P5025A-03-S

# Safety Service Note

## P5025A Keysight Streamline USB Vector Network Analyzer

“POTENTIAL BURN INJURY (HIGH TEMPERATURE) HAZARD”

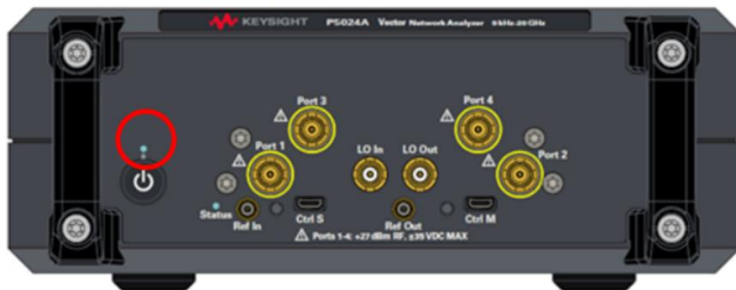
VNA fails to start with the following symptoms.

1. LED indicator (below circle) turns red.
2. cooling fan does not work
3. If user leaves the VNA with this LED indicator red without turning off power switch, it continues to overheat and becomes too hot.

Solution-1: Update VNA firmware by user

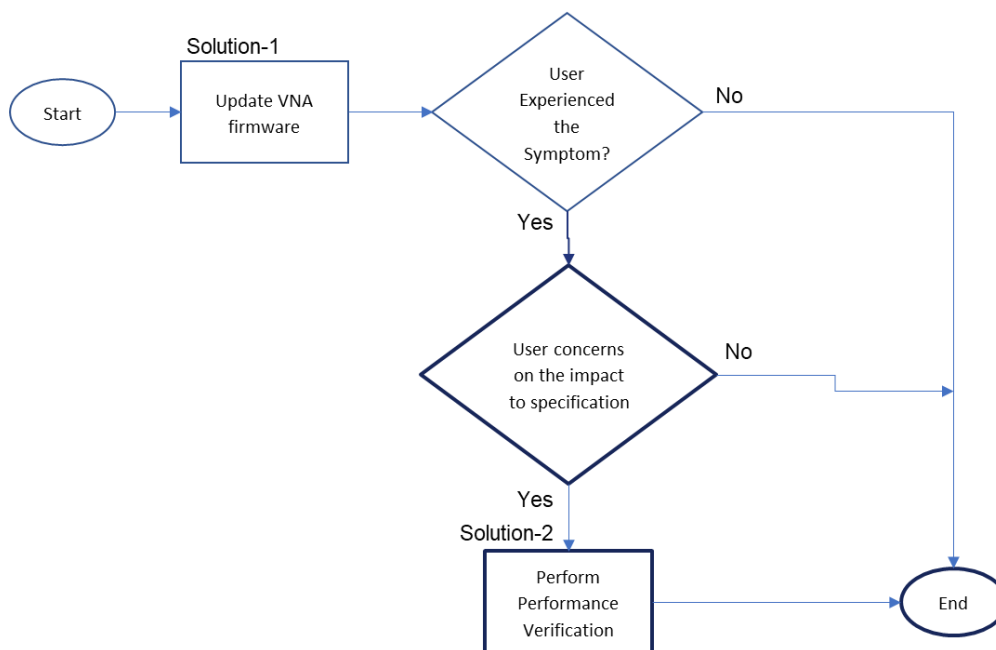
**Action-1:** Updating the firmware eliminates this potential risk of overheating.

1. **Install the latest VNA firmware Rev. A.15.40.13 or newer** on users' controller PC(s).  
The latest firmware enhanced the thermal fan control mechanism.
2. Once the latest firmware is installed, proceed with the restart of both **controller PC** and **VNA**.
3. Launch the VNA firmware. Ensure VNA powers up and launches into firmware correctly after firmware update is done.
